## RV dwellers can park on private property in residential areas under new ordinance

**From:** [Tanner, Rachael](#)  
**To:** [David Rogosa](#)  
**Cc:** [Planning Commission](#)  
**Subject:** RE: 985 Channing. Follow-up commentary and materials from Oct 13 deliberations, D Rogosa  
**Date:** Wednesday, November 24, 2021 1:03:59 PM  
**Attachments:** [DRogosaPTC11-10.pdf](#)  
[image001.png](#)  
[image002.png](#)  
[image004.png](#)  
[image005.png](#)  
[image006.png](#)  
[image007.png](#)

DUNLAP RESIDENCE

985 CHANNING AVENUE  
 PALO ALTO, CA 94301

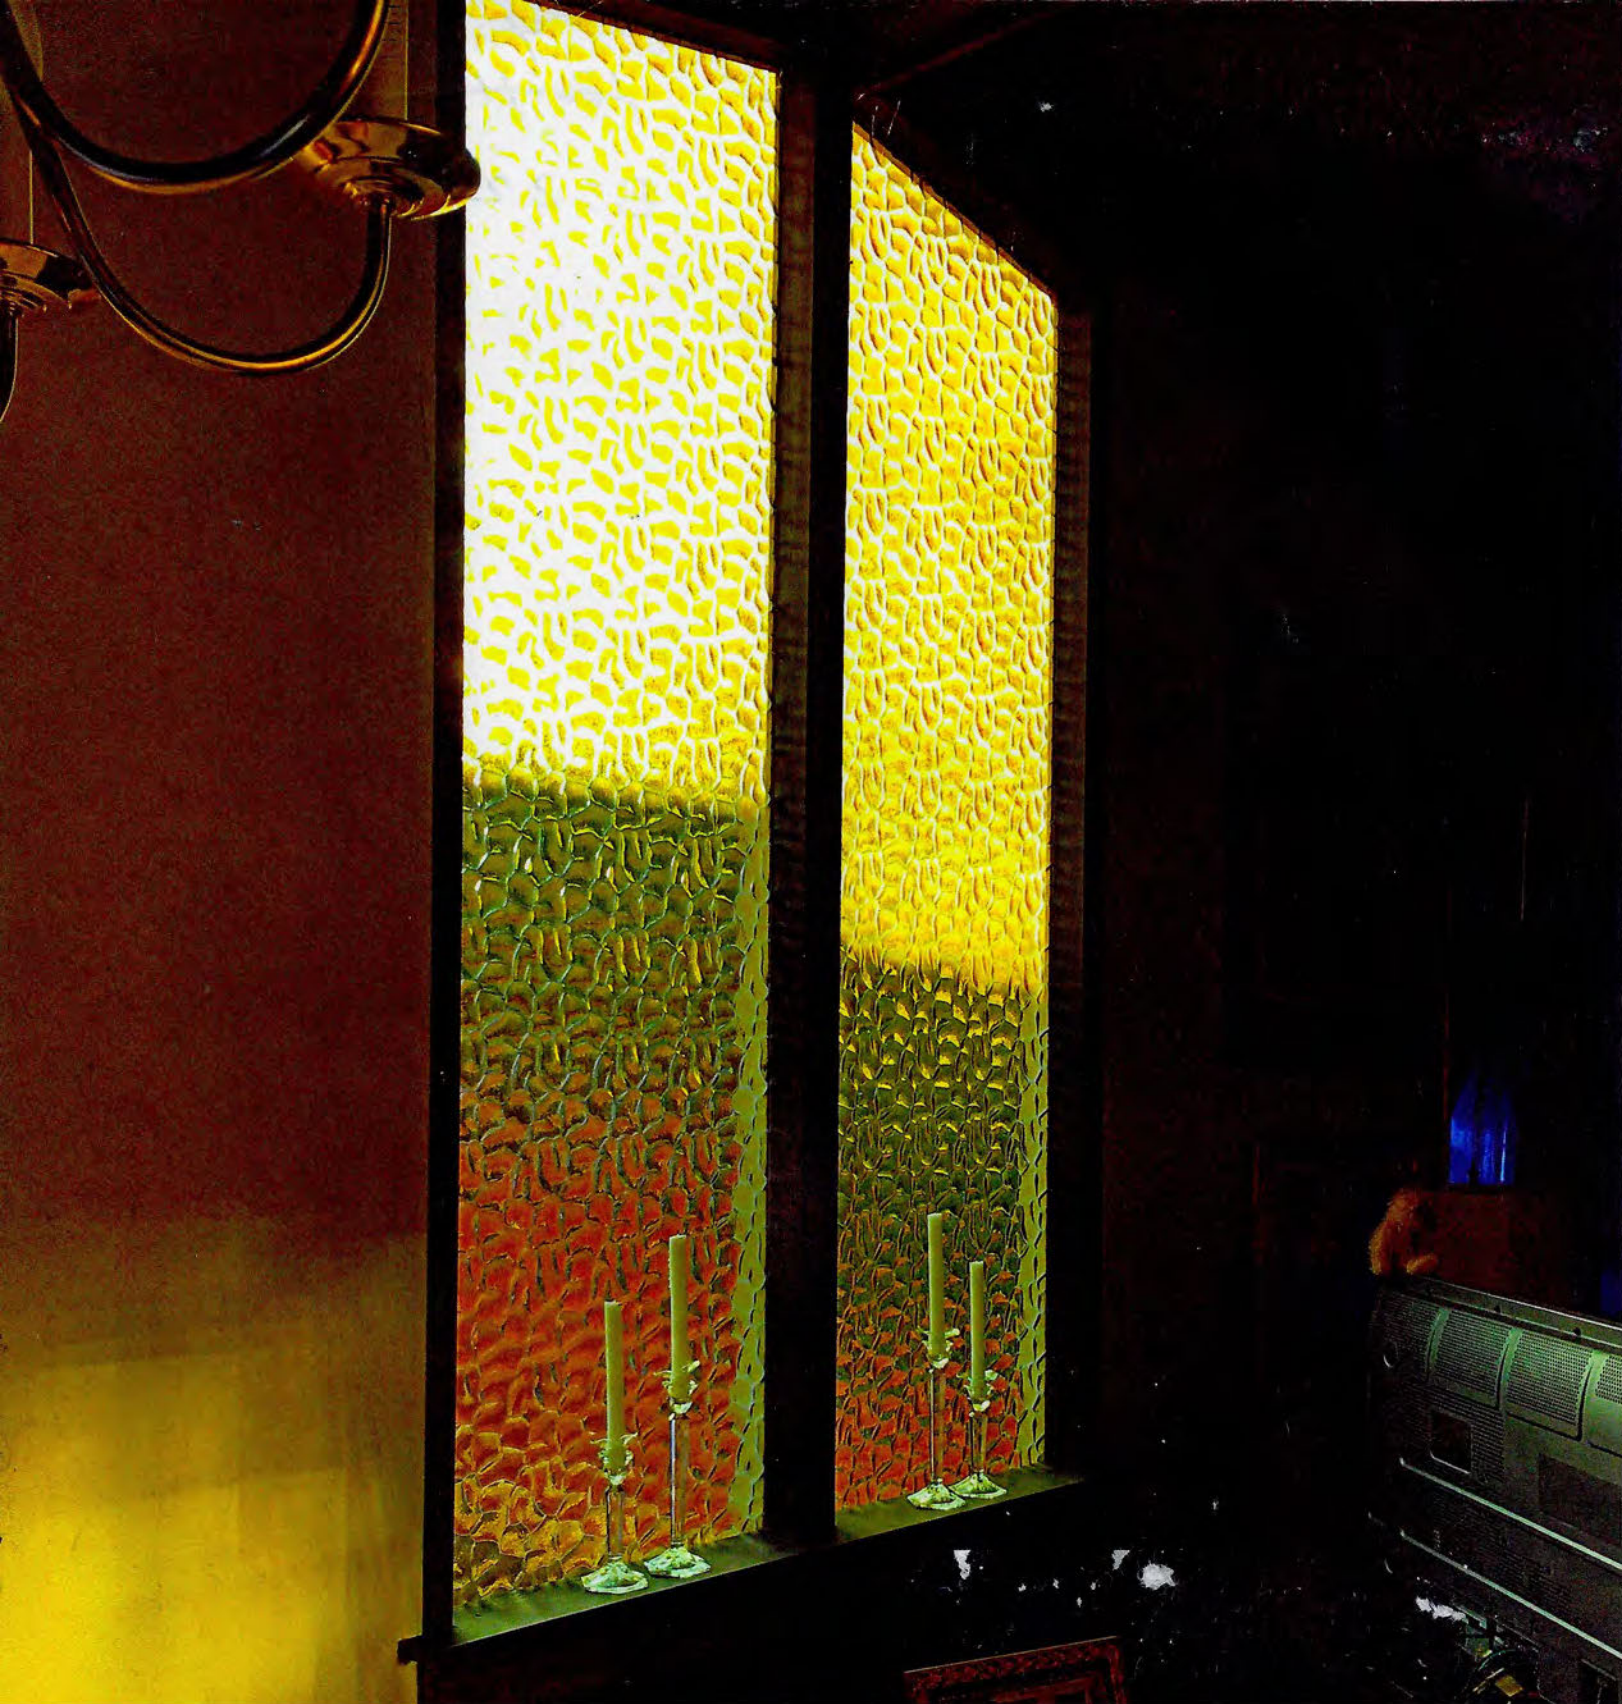
- Currently, and in spite of daylight planes, the house at 985 Channing blocks a portion of our natural morning sunlight, as you can see in the 2 photos (Exhibit #1 and Exhibit #2) I have submitted. The photos show our East-side facing window in our living room. This is the only room we spend time in during the day as the others are bedrooms.

EXISTING & PROPOSED SITE PLANS

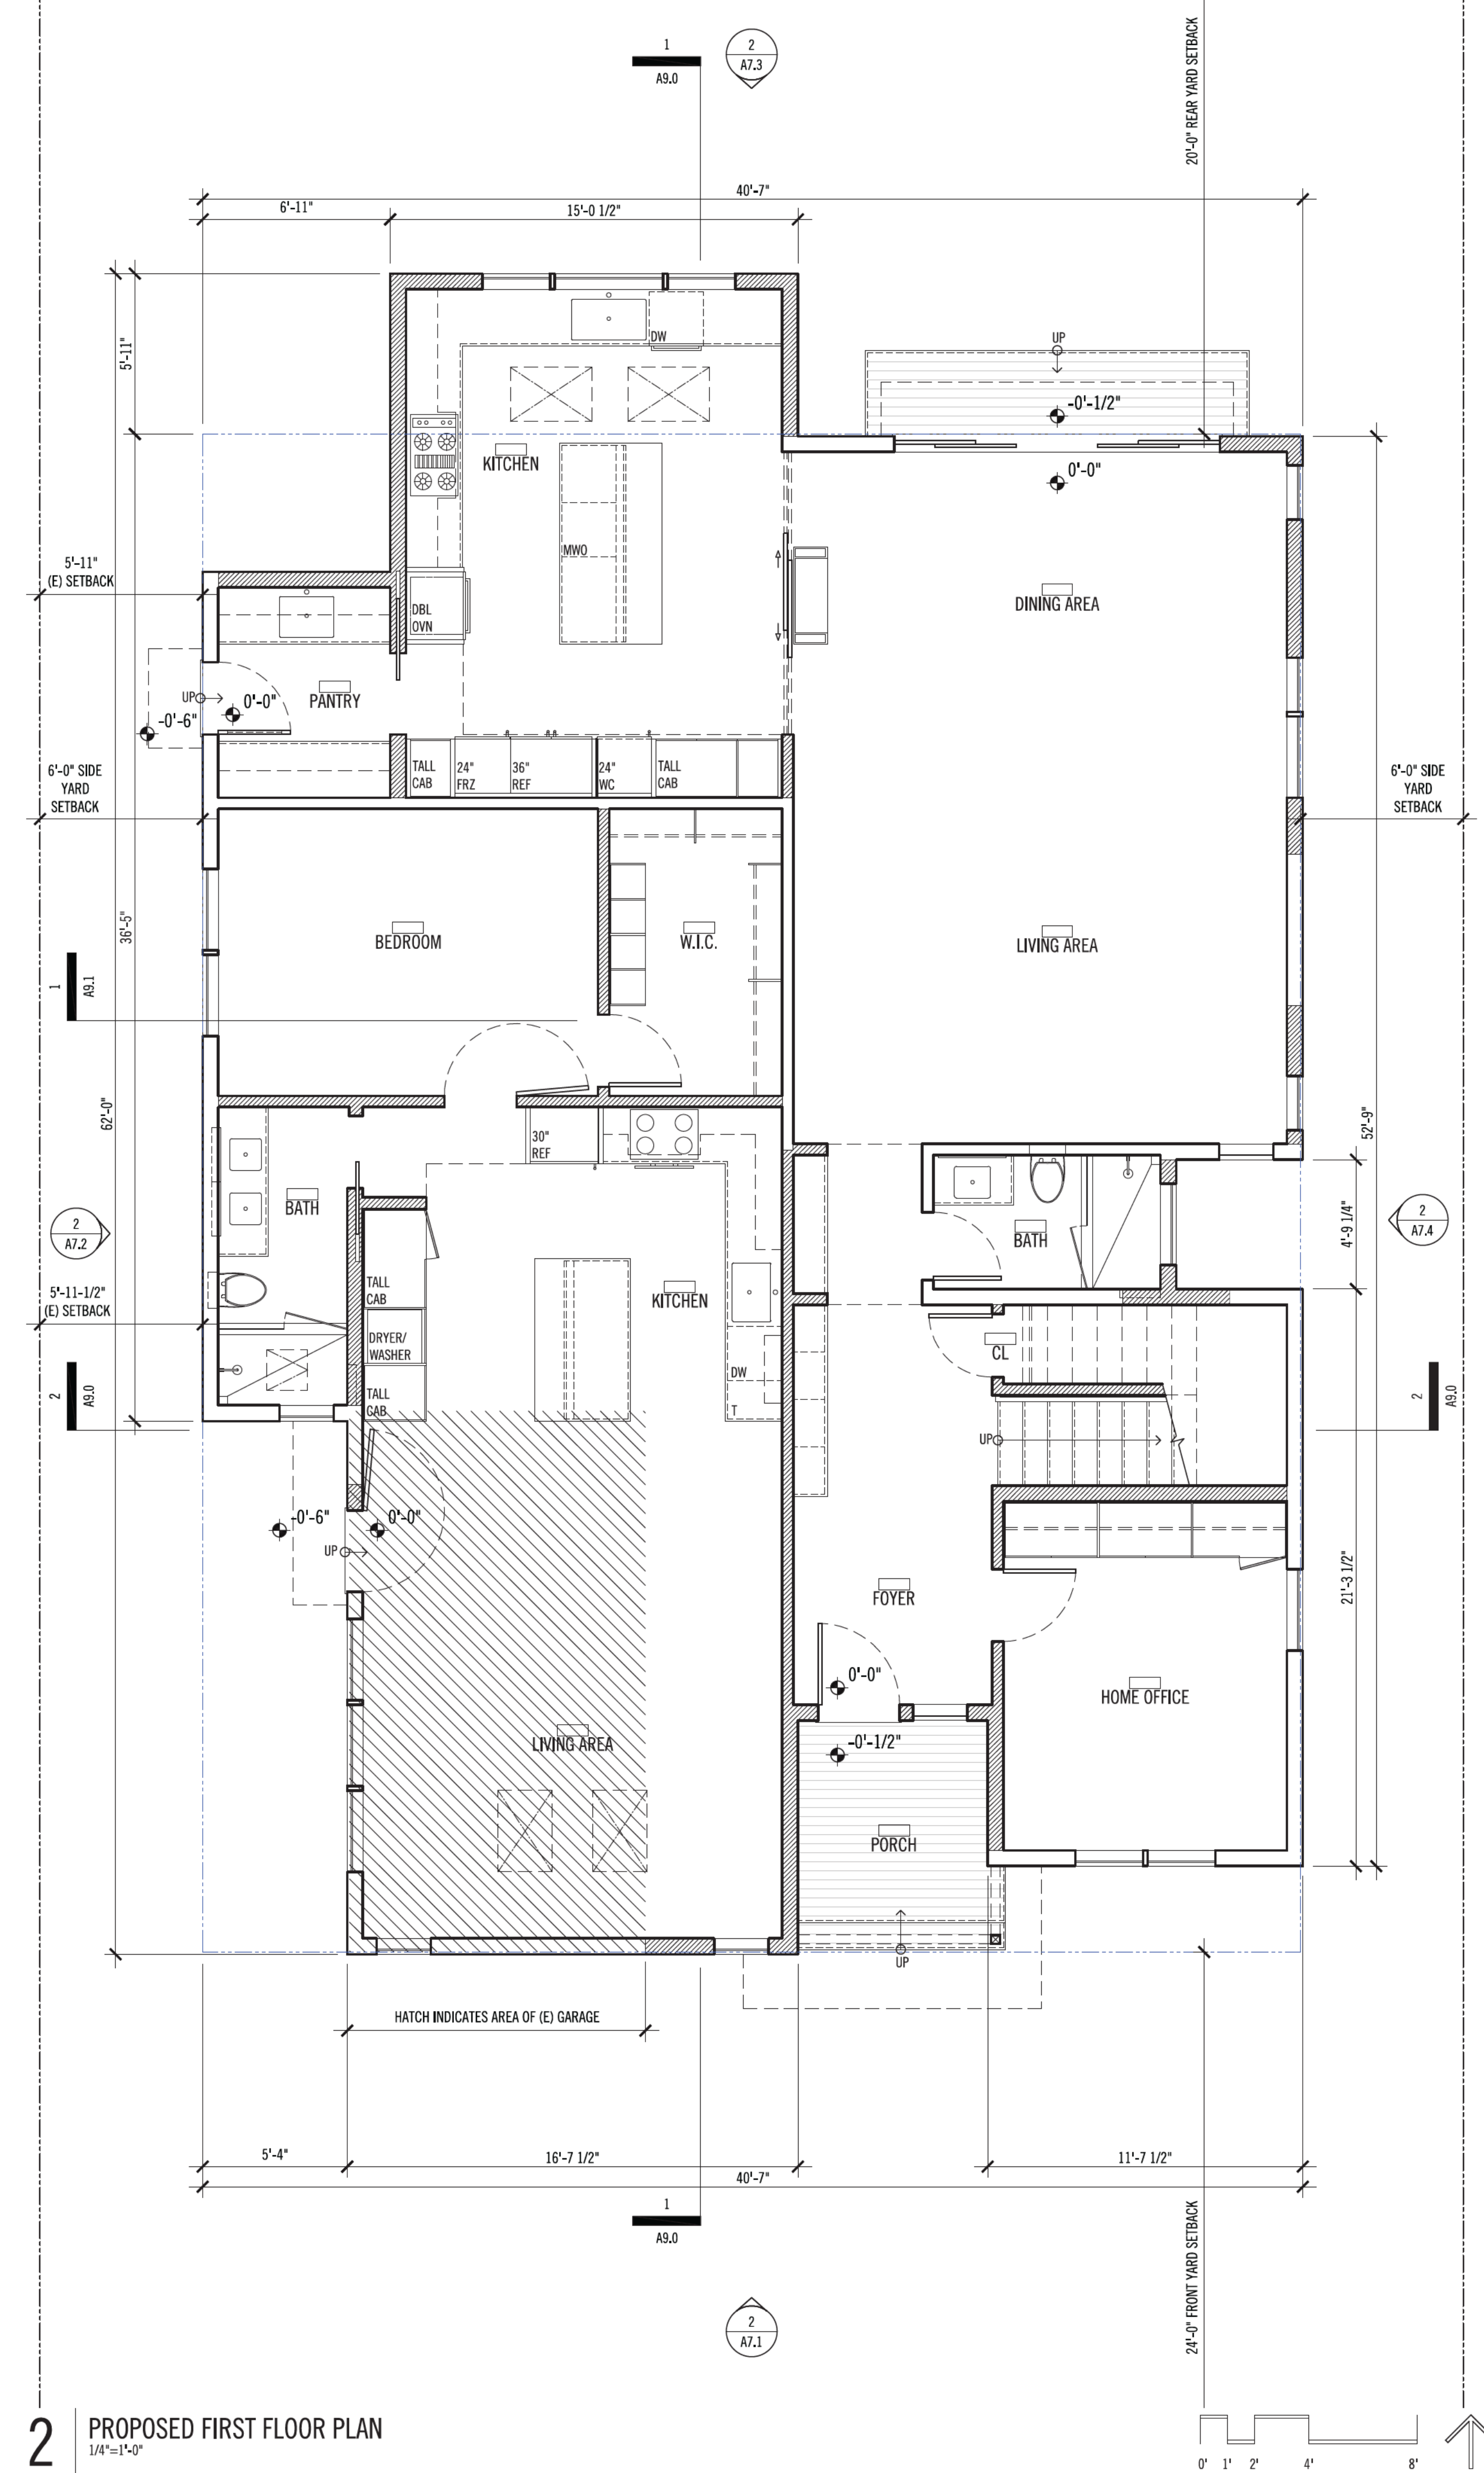
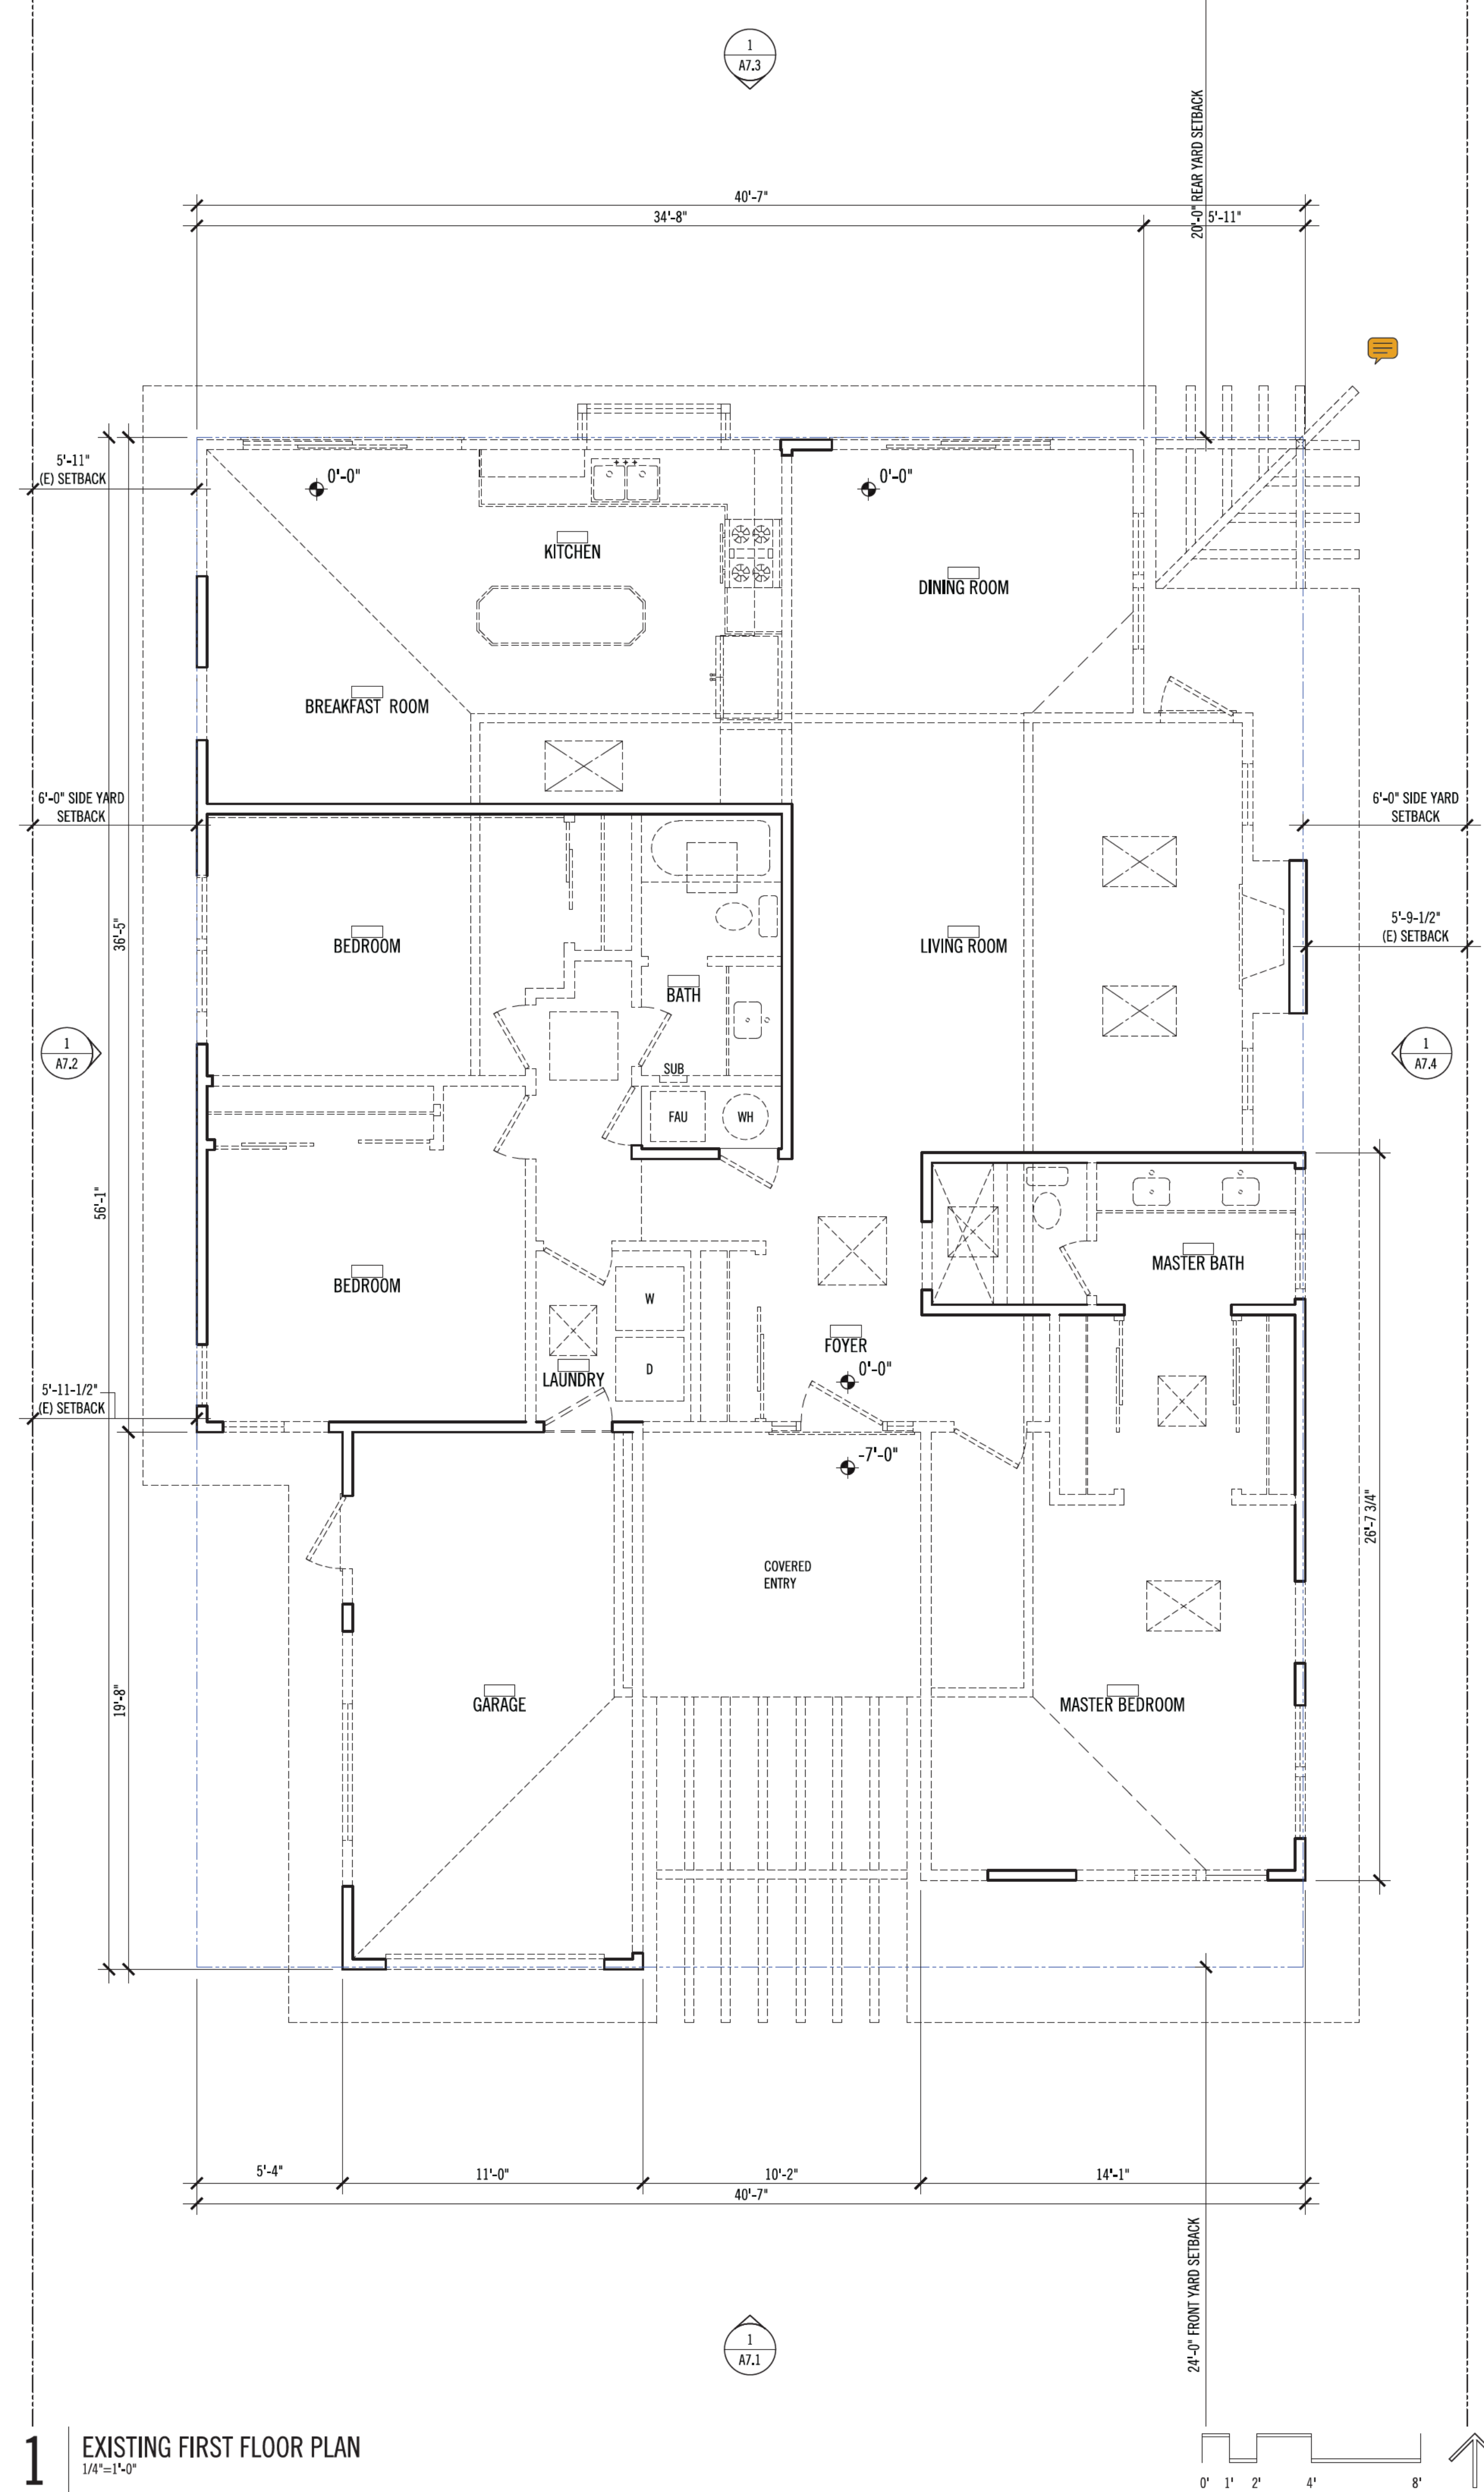
Any uncovered parking provided that is adjacent to a wall must provide an additional .5' of clearance space for door swing. Update the plans to provide this information.

Note driveway material

Update to show

IR-2: To meet guideline one and five, revise the site plan to provide landscape, such as medium sized screening trees or tall screening shrubs within side yards between this home and adjacent homes. Where existing landscape exists fill gaps in the landscape. Landscape can also be used to mitigate privacy, but it cannot be the primary means of privacy mitigation where direct sight lines exist to neighboring property. Provide plant choices with botanical names and quantities; indicate 24-inch box size and 8-foot minimum installed height for trees and 15-gallon size and 8-foot minimum installed height for screening shrubs.
